Subject: SCI-823-Ph3: Portsmouth Bypass Transmission Line Crossing Part 1 of 2

Attachments: Span Crossing Maps.pdf; PnPs(part1).pdf

SHEET 26 OF 39 SHEETS

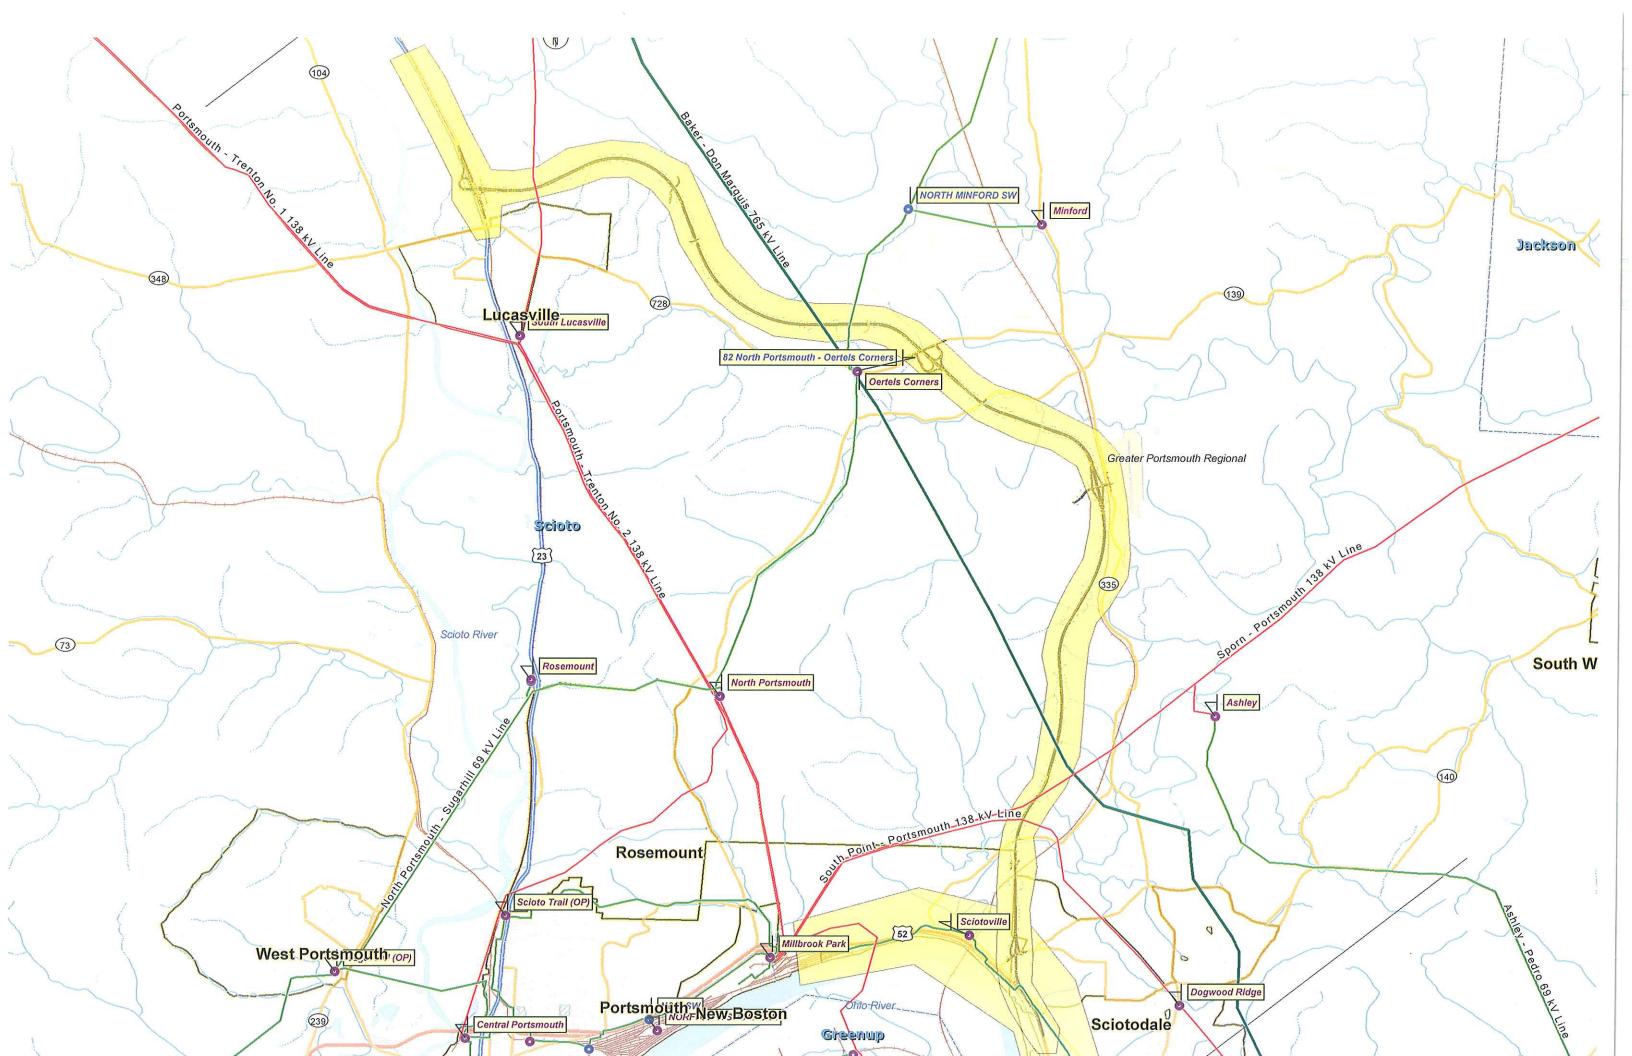
After briefly reviewing the elevations on the only profile drawing that we received (sta. 202+00 to sta. 214+50) and cross checking it to the clearance that is required, it appears that this particular span will most likely meet clearance. I would like for you to confirm this as I was only able to interpret the location of the proposed roadway based on the topography of the span.
